N6732B-01

S E R V I C E N O T E

N6732B 50W DC Power Module

Current Measurement accuracy is out of specification when there is voltage being sourced at the output terminals.

Location of C36 and C37

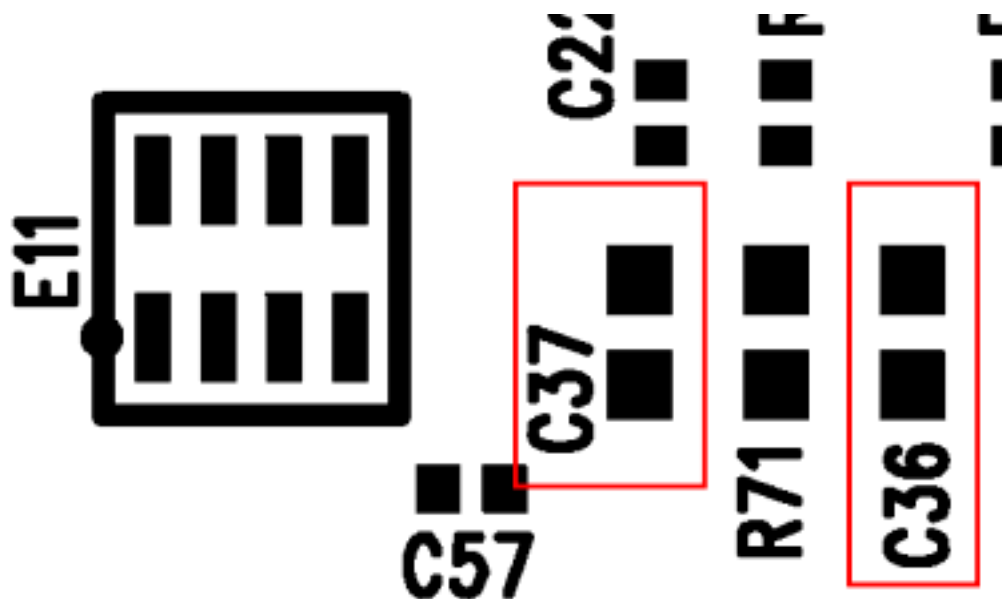
Due to some noise filtering issues, the current measurement accuracy will be out of specification by a fixed offset when there is a voltage being sourced at the output terminals. If the output is shorted, the current measurement accuracy will be within specifications. Please note that the performance verification test will not catch this.

If this measurement is out of specification, replace capacitors C36 and C37 on the DPM assembly (this is the assembly that is vertically mounted in the unit that looks similar to a PC memory module) with part number 0160-7809. After the capacitors are changed, the unit will require re-calibration. After the capacitors are replaced, check the make sure that the unit is in specification by applying 75% of the full voltage range while attached to a load drawing 50 mA to 70 mA. If the current measurement is within the specification, then the unit has been repaired.
